January 25, 1990

The attached information on a capping alternative for the upper estuary of New Bedford Harbor is submitted for your use. It focuses on the questions of cap thickness, construction costs and impacts to the estuary. Copies have been sent to Doug Allen at E.C. Jordan and Alan Fowler at Ebasco.

New Bedford Harbor Superfund Site
Upper Estuary Capping Alternative

FIGURE 1

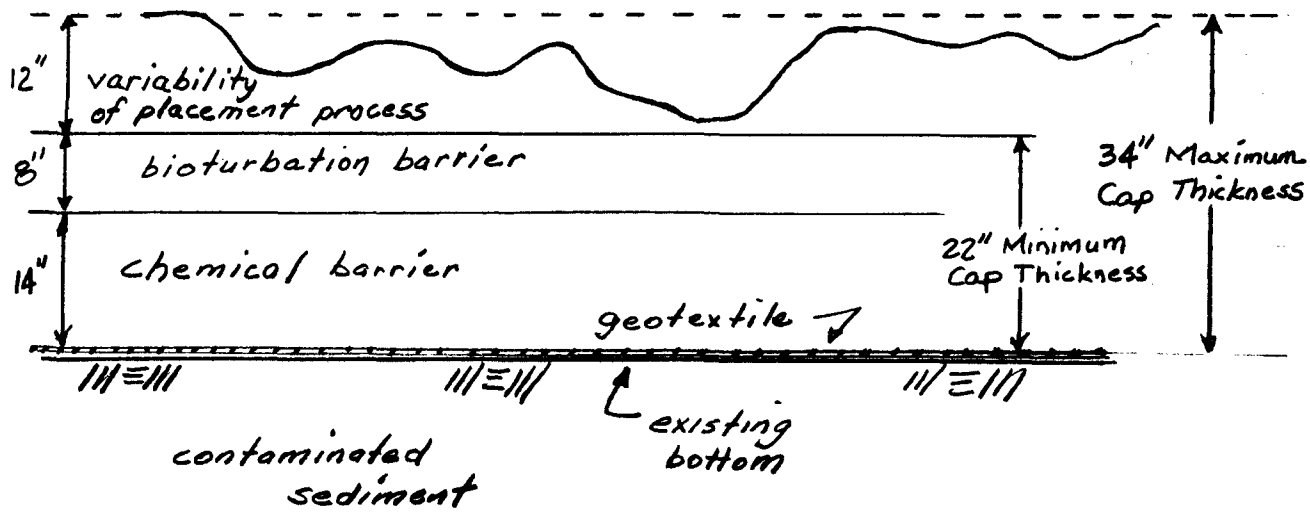
The 45 cm (17.7 inch) cap discussed in the AVX proposal is not considered sufficient to contain the contaminants or to accurately address impacts to the upper estuary. The various components of the cap are discussed below along with our recommendations.

e) The various components of the cap are shown below and in figure 1.

chemical barrier	35 cm	14 inches
bioturbation layer	20 cm	8 inches
Minimum Cap thickness		22 inches
variability of placement process		12 inches
Maximum Cap In Place		34 inches

The cap thickness resulting from an effort to install a 22 inch cap will vary from 22 - 34 inches. Costs of construction and impacts to the estuary need to be evaluated based on the maximum cap thickness.

SHEET 2 OF 2

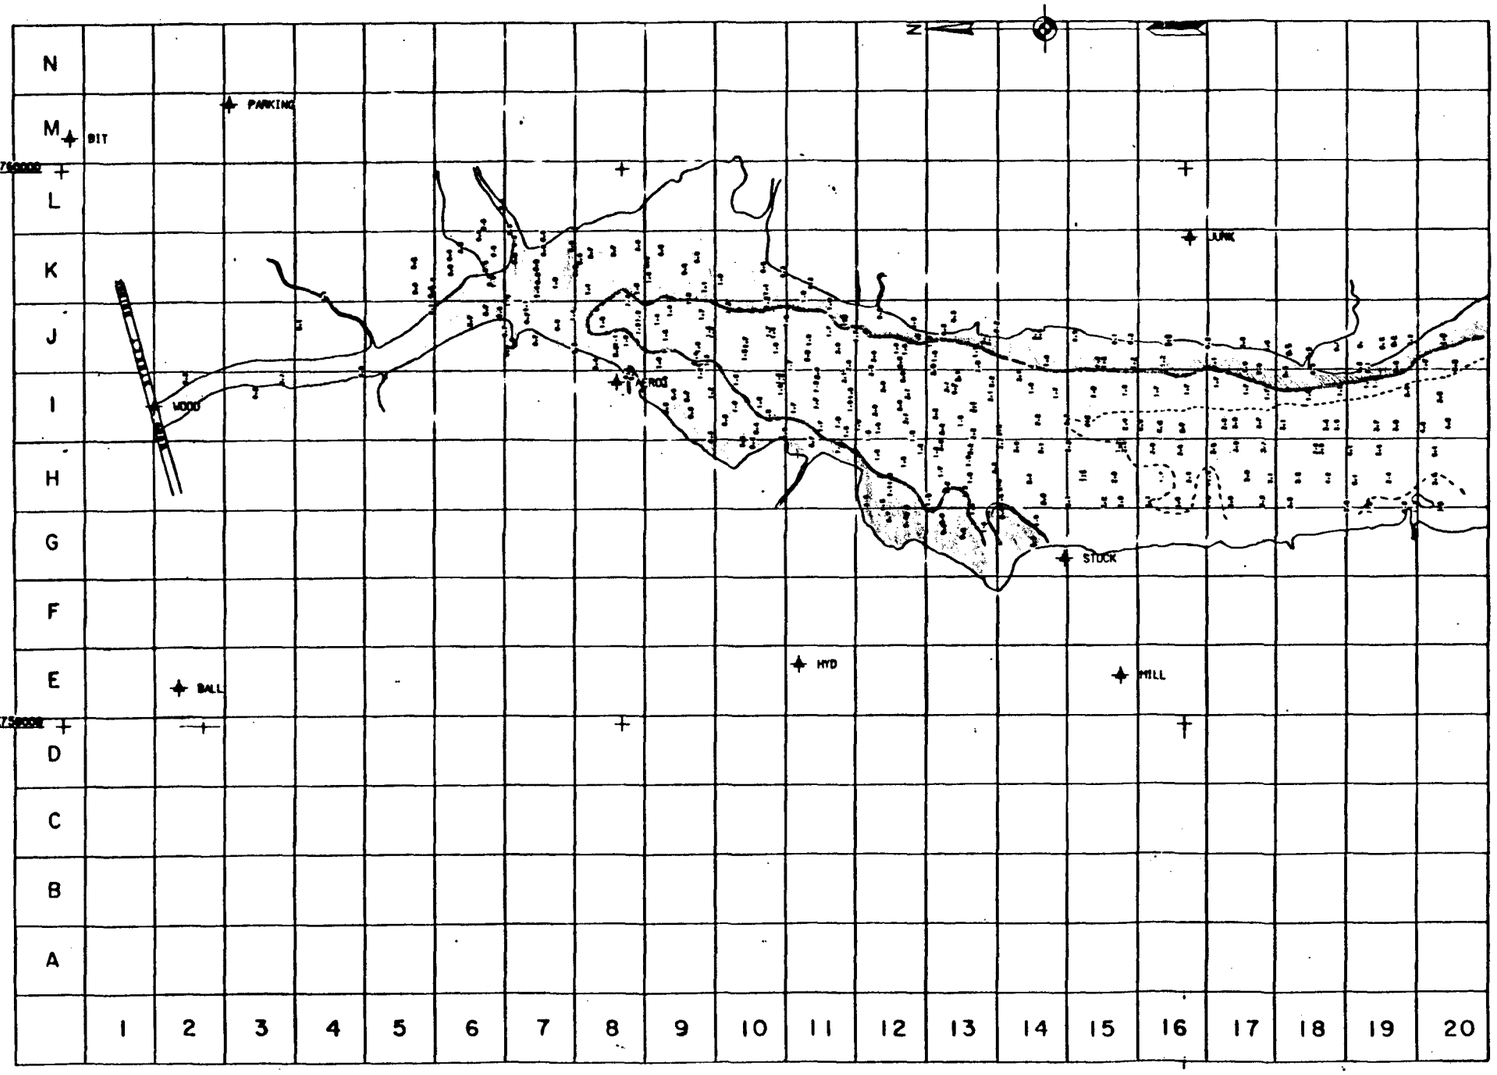
The most significant impact associated with a capping alternative is the creation of intertidal area. Attachment 2 is a hydrographic survey of the upper estuary showing the changes caused by the placement of a 34 inch and 22 inch cap. In each case it was assumed that 6 inches of settlement would result from cap placement so that the drawings reflect changes of 28 and 16 inches in the elevation of the estuary bottom. Placement of a 34 inch cap results in the creation of approximately 97 acres of intertidal area while placement of the 22 inch cap results in the creation of approximately 61 acres of intertidal area.

- RED SHADING INDICATES THE INTERTIDAL AREA CREATED BY RAISING THE BOTTOM ELEVATION BY 16 INCHES
- YELLOW SHADING INDICATES THE INTERTIDAL AREA CREATED BY RAISING THE BOTTOM ELEVATION AN ADDITIONAL 12 INCHES FOR A TOTAL OF 28 INCHES.
